MEETING SUMMARY
BRUNSWICK HYDROELECTRIC PROJECT

FERC NO. 2284

DOWNSTREAM FISH PASSAGE ALTERNATIVES MEETING

January 27, 2026

Alternative D4A - Multiple Fish Friendly
Runner Replacements

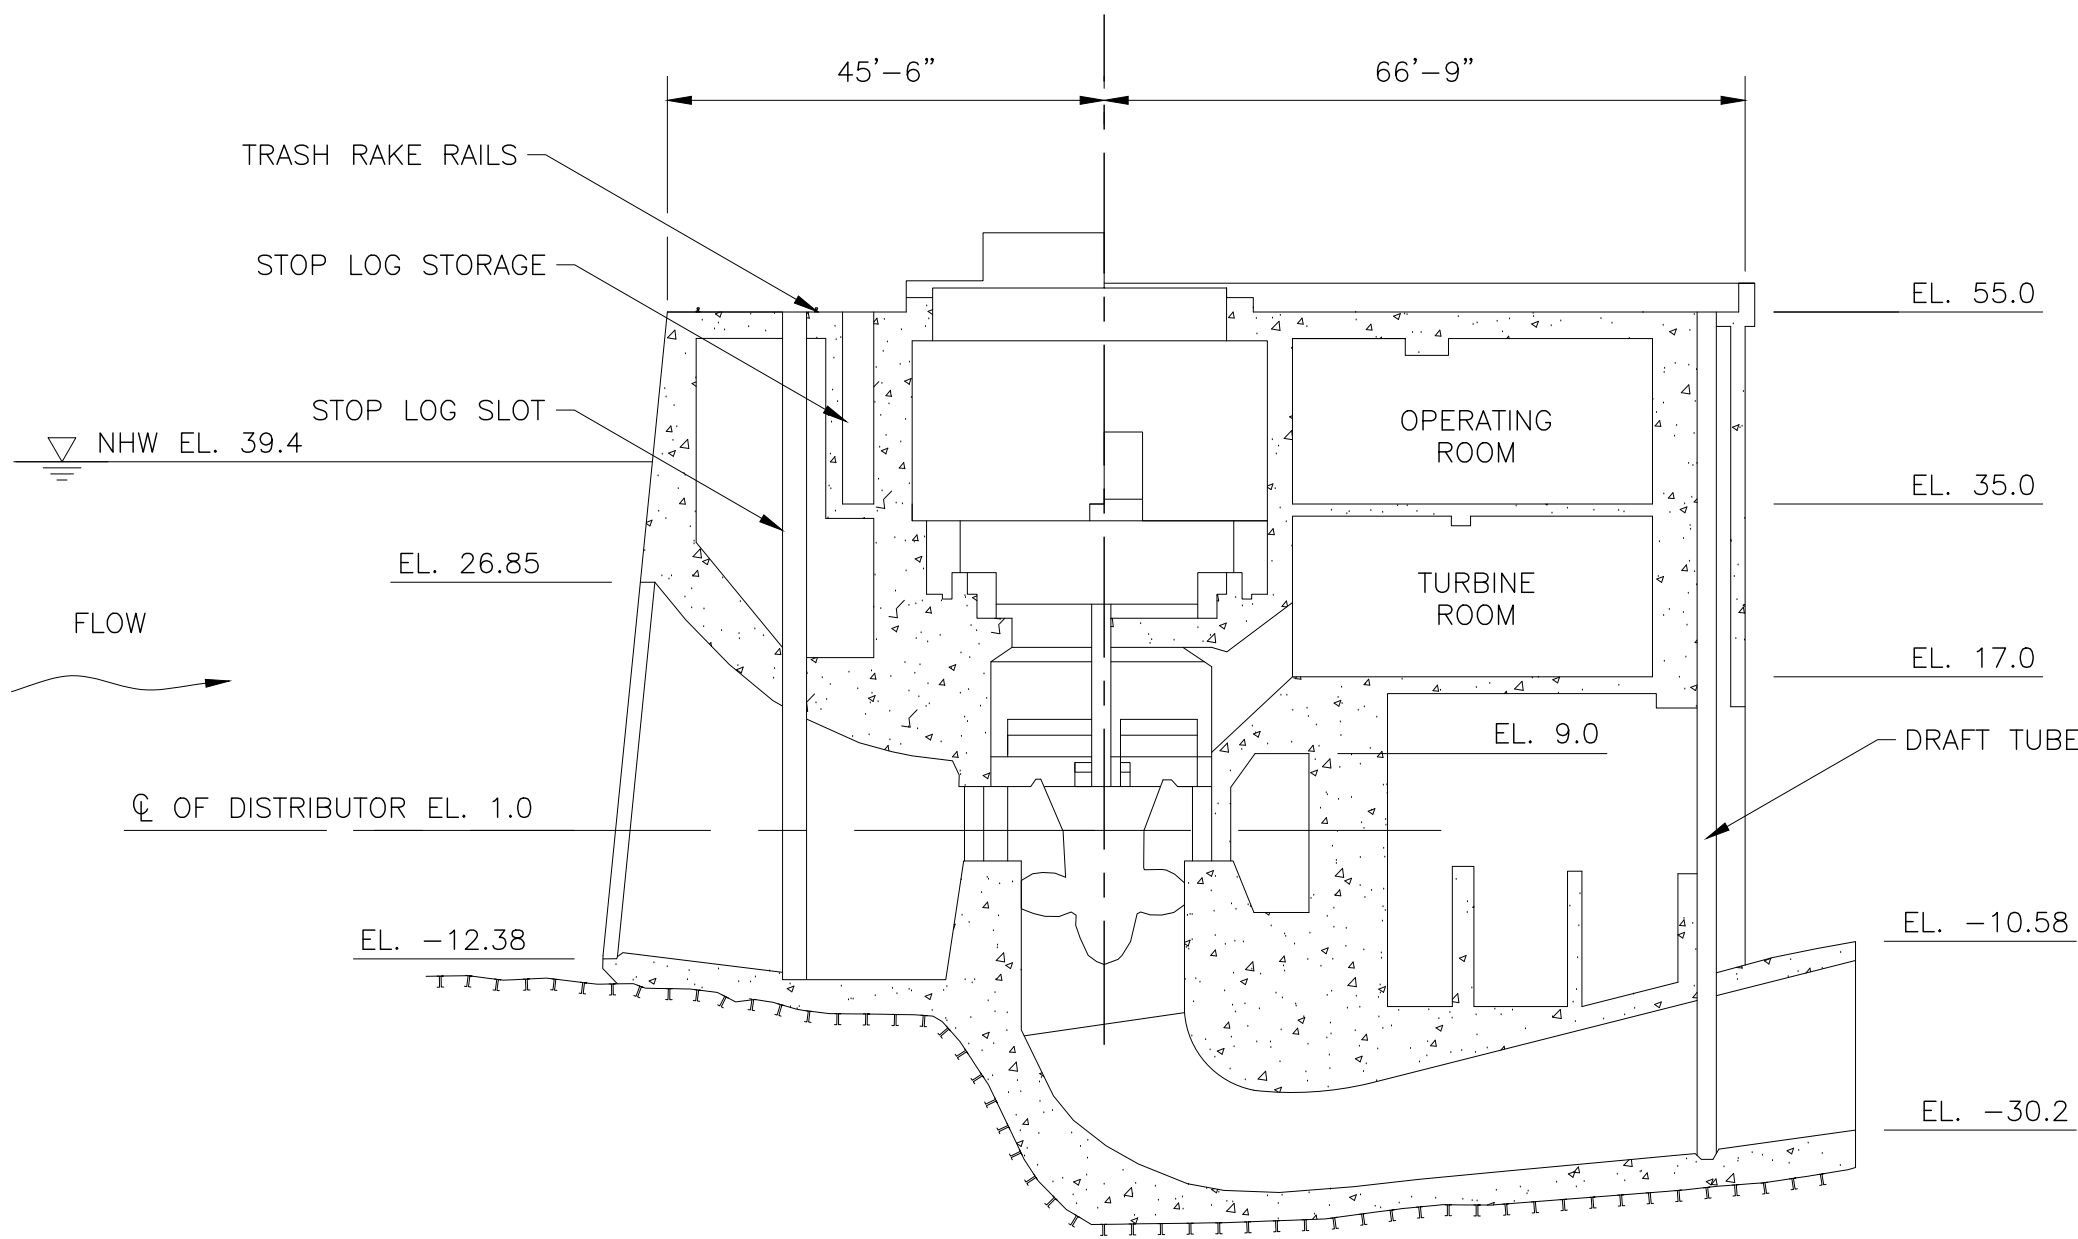
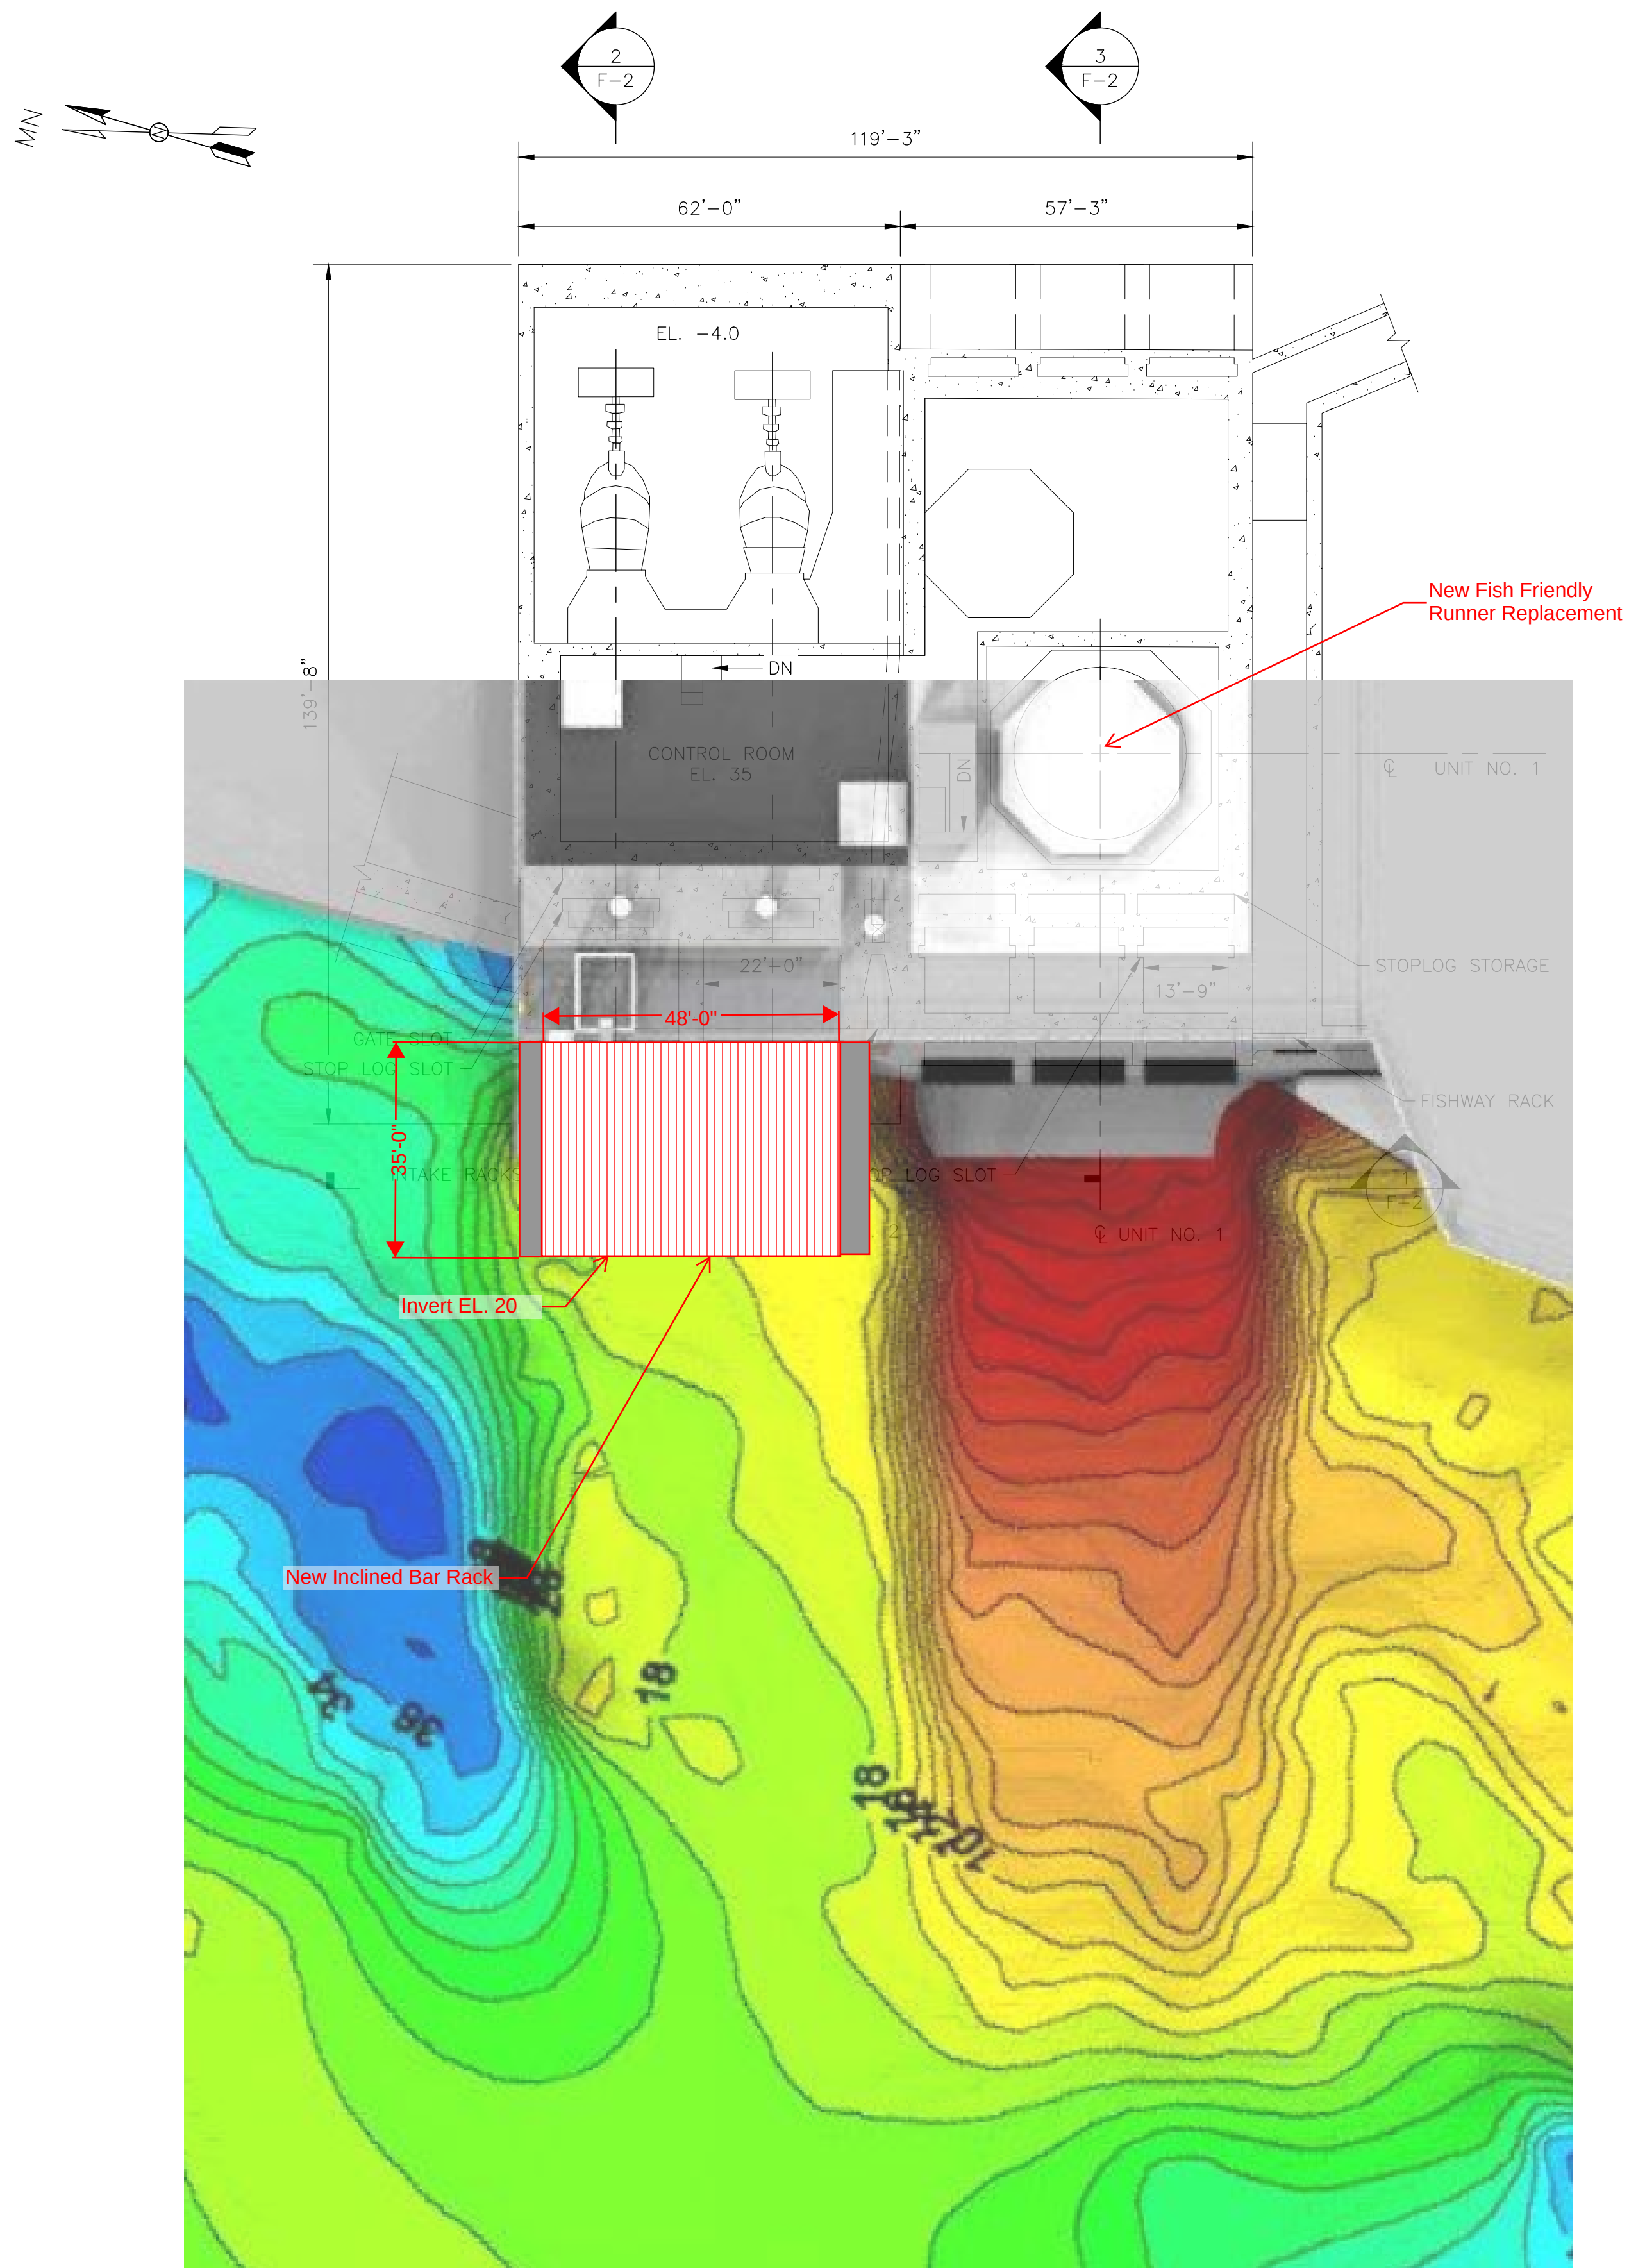
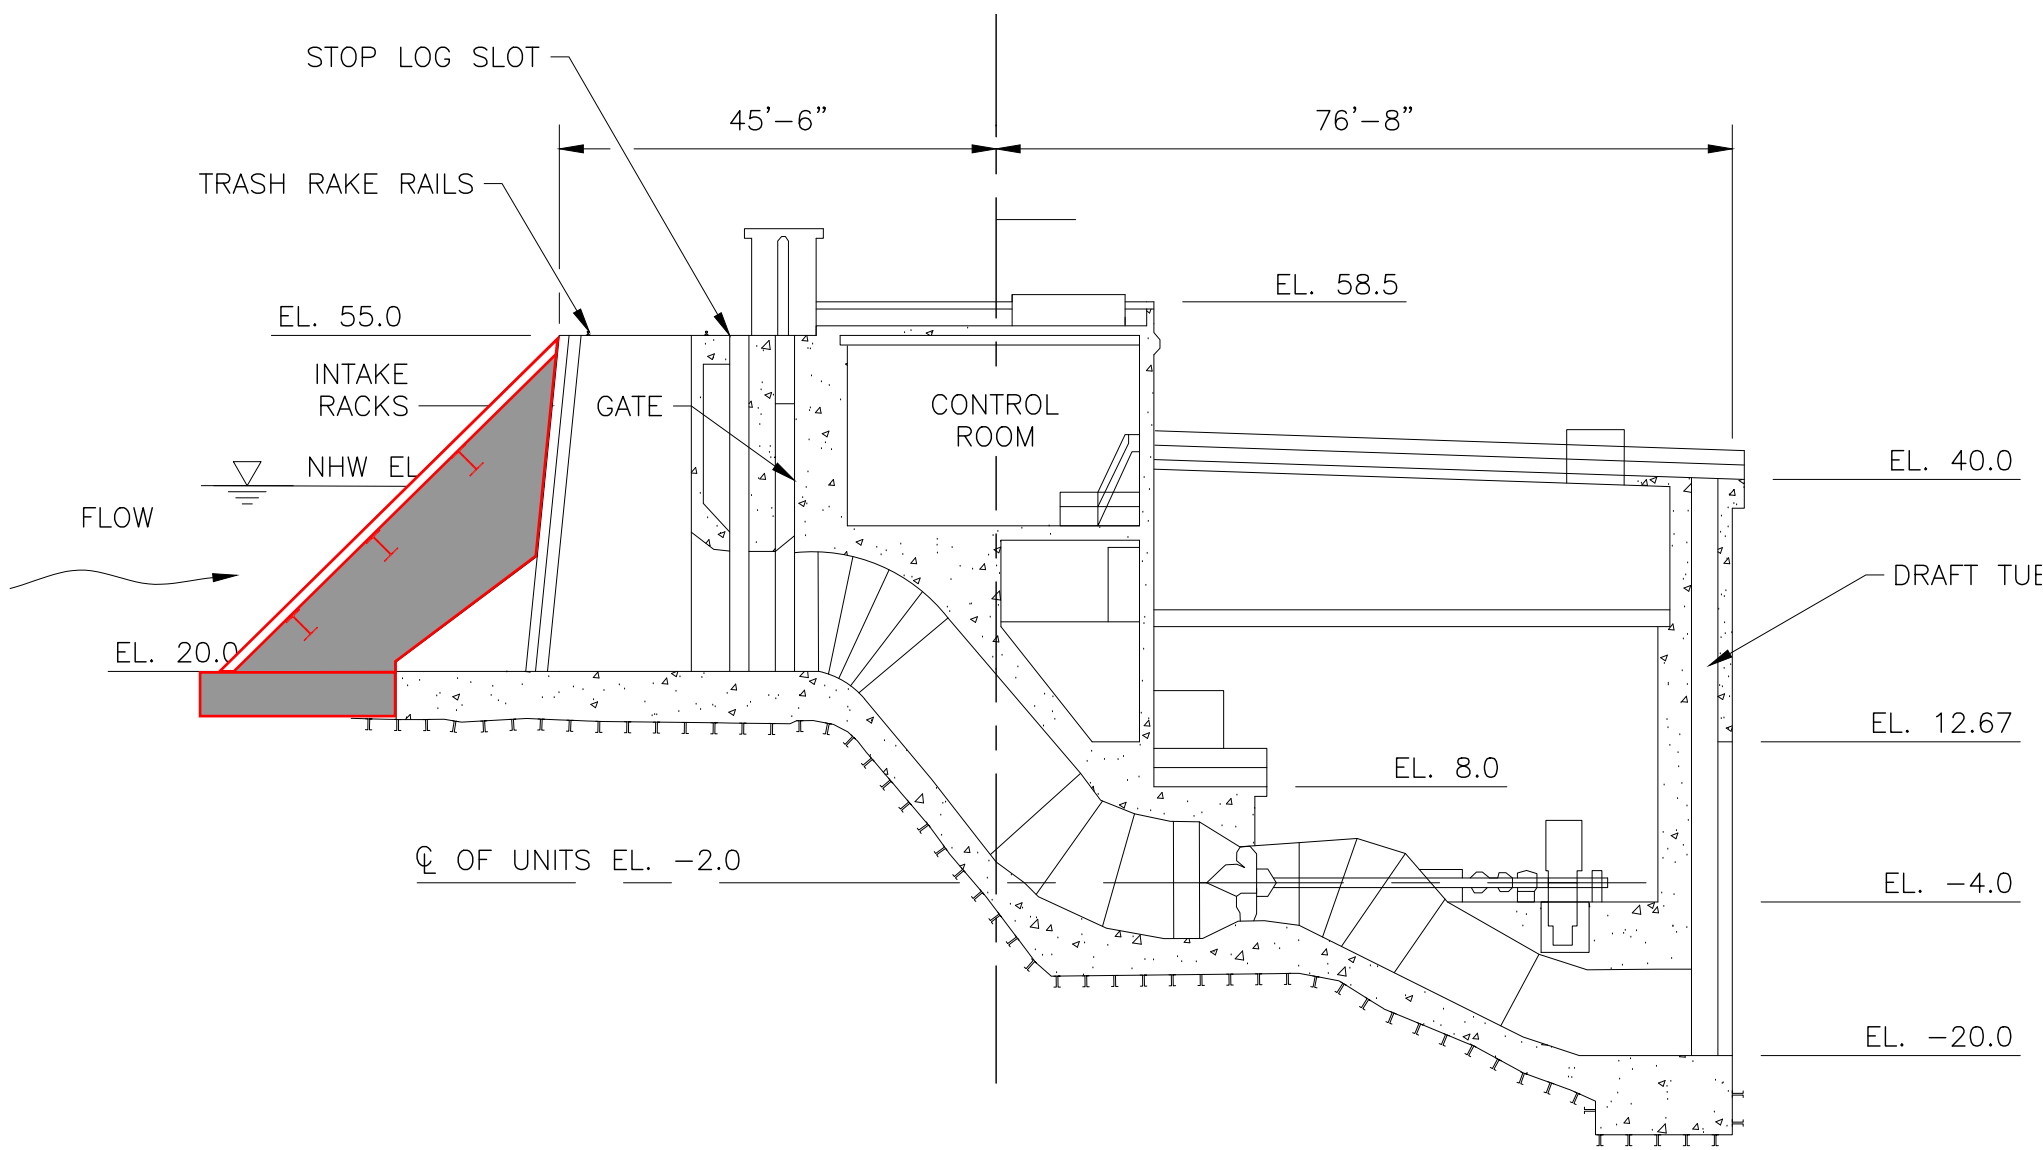
Matt Buhyoff commented that the 3 1/2-inch spacing would exclude approximately 30% of adult salmon kelts, and it made him apprehensive that we could be relying on modeling to assess survival, and modifying the clear spacing might be necessary to protect kelts from entrainment. Matt Buhyoff stated the spacing on the rack does not need to get much finer to prevent entrainment of kelts. Don Dow added that clear spacing of 2 1/2 inches might be the appropriate threshold.

Lucas Stiles stated that he was thinking from the perspective that the rack clear spacing should be increased so kelts could pass through the turbines, as this alternative does not consist of a bypass and spillage occurs approximately 30 to 40% of the time. Don Dow stated that without effectiveness testing it would be difficult to assess the impact of passing kelts through Natel runner turbines.

Vladimir Douhovnikoff asked if alternatives could be combined, and specifically whether Alternatives 1 and 4 could be combined. Lucas Stiles replied that there would not be a reason to combine the two, since the concept of the Natel runner is for fish to pass through the turbines with a very high rate of survival, therefore, there would be no need to exclude fish from entrainment with an angled rack.

Ed Friedman asked about a scenario where the Natel turbine runners did not work as anticipated. Lucas Stiles stated that it is a new technology that is just emerging and it's effectiveness is going to require additional evaluation and study. If this alternative were pursued, then Natel would need to do an analysis on expected turbine survival for the various species. That's not something that is being proposed as part of this initial study, but it's something that could be looked at in the future.

Ed Friedman asked if punch plates were going to be considered. Lucas Stiles stated that punch plates are used on some West Coast projects, but not typically used for intakes on the East Coast. In addition, punch plates create many issues from an operations perspective, as punch plates cannot be cleaned with a trash rake very easily. Ed Friedman stated that punch plates are used in Gardner (perhaps seasonally), but that is a smaller facility. Don Dow stated that KEI has been using punch plates at a few sites in the Northeast. Lucas noted use as a seasonal overlay, noting that cleaning requires temporary removal of the overlay panels.
